Re: **NOV N97-47-1-1**
Abatement Plans
Gordon Creek No. 2/7/8 Mines
ACT / 007 / 016
Carbon County, Utah

**Proposed Pond Reconstruction Plan
Gordon Creek 2/7/8 Mine
Sediment Pond**

FIGURE 1
PROPOSED POND RECONSTRUCTION

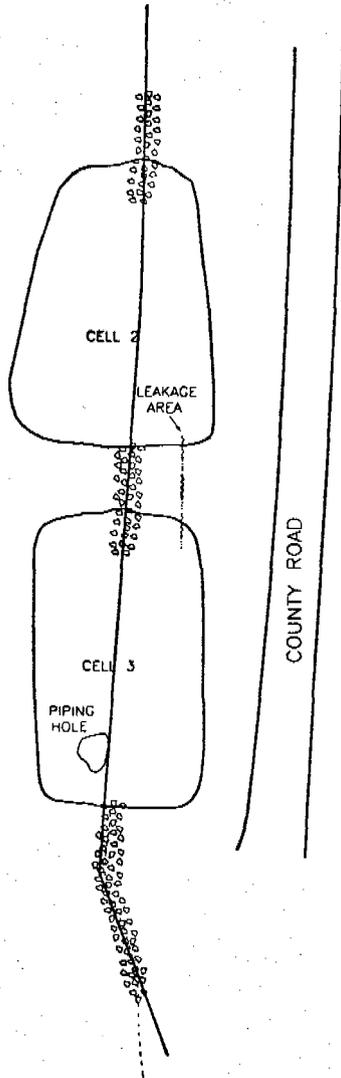
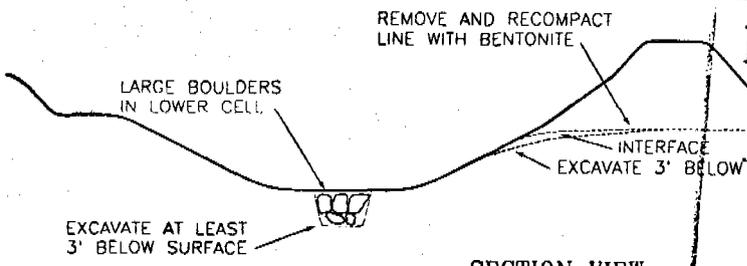
The area of leakage in the No. 2 cell appears to be along the interface of the excavated pond and the old road fill. The leakage in the 3rd or lower cell appears to be where the excavated pond came into close proximity of the old channel, allowing water to pipe through the large rocks and travel underground for a moderate distance before surfacing.

The attached Figure 1 will show a typical plan and section of the pond and proposed reconstruction. The proposed reconstruction steps are as follows:

- (1) The road side of the pond will be excavated with a trackhoe to a depth at least 3' below the area of leakage;*
- (2) Excessive coal or other non-compactible debris will be removed from the excavated material;*
- (3) The excavated material will then be recompacted in lifts not to exceed 12" up to the elevation of the dam;*
- (4) Bentonite clay will be mixed at a ratio of approximately 50/50 with the top 6" of fill material from the edge of the spillway to the bank along the road;*
- (5) The piping hole in the lower cell will also be excavated to a depth of at least 3' below the surface (or a greater distance as needed to remove the large rocks);*
- (6) The area will then be recompacted with soil material with approximately 50% bentonite;*
- (7) The redisturbed area will be final dressed and reseeded according to the reclamation plan.*
